### KI-208-1 / KI-208-2 R66 Placards and Markings Kit Instructions

*For compliance with R66 Service Bulletin SB-02*

FIGURE 1

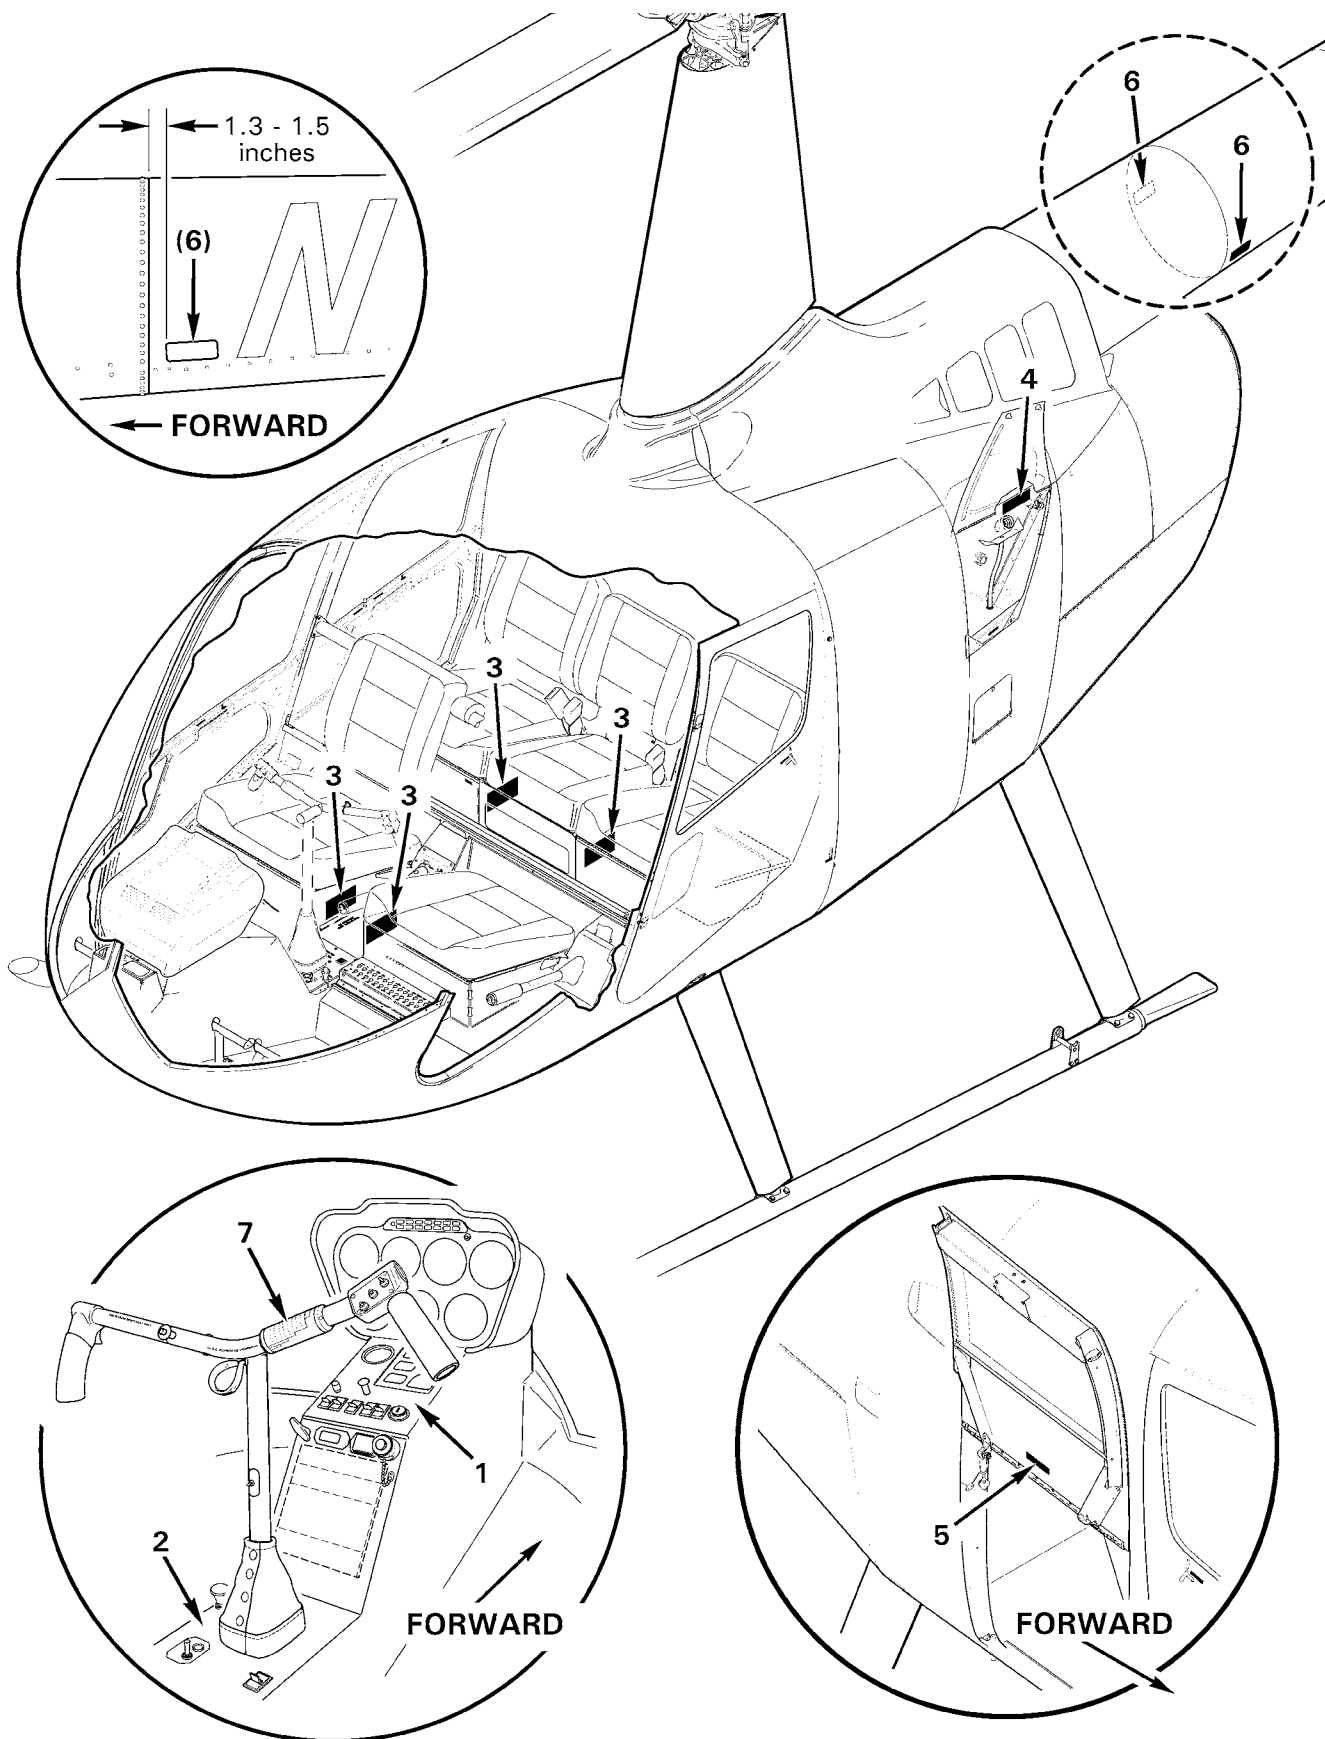
1. Refer to Figure 1, item 1 and Figure 2. Attach D819-3 decal to B051-20 face assembly as shown.
2. Refer to Figure 1, item 2 and Figure 3. Attach D819-4 decal to F444-1 cyclic cover as shown.
3. Refer to Figure 1, item 3 (4 places). In seat compartments, note locations and remove F654-10 revision F (or prior) decals. Attach F654-10 revision G (or subsequent) decals at same locations.
4. Refer to Figure 1, item 4. On oil tank, note location and remove F654-3 revision F (or prior) decal. Attach F654-3 revision G (or subsequent) decal at same location.

5. Refer to Figure 1, item 5. On baggage compartment door, note location and remove F654-7 revision F (or prior) decal. Attach F654-7 revision G (or subsequent) decal at same location.
6. Perform KI-208-2 kit instructions.

1. Replace helicopter's plastic-laminated MT699-1 Pilot's Checklist with Aug 11 revision (or subsequent).
2. Refer to Figure 1, item 6 (2 places). Unless previously installed, attach A654-94 decals to tailcone as shown.

3. Refer to Figure 1, item 7. Remove F654-4 revision H (or prior) decal. Center, straighten, and attach F654-4 revision I (or subsequent) decal to rotatable tube, bottom to top.
4. Using a razor blade, trim decal flush with ends of tube without damaging nylon collars. Touch-up decal trimmed edges with black permanent ink, as required.
5. Make appropriate maintenance record entries.
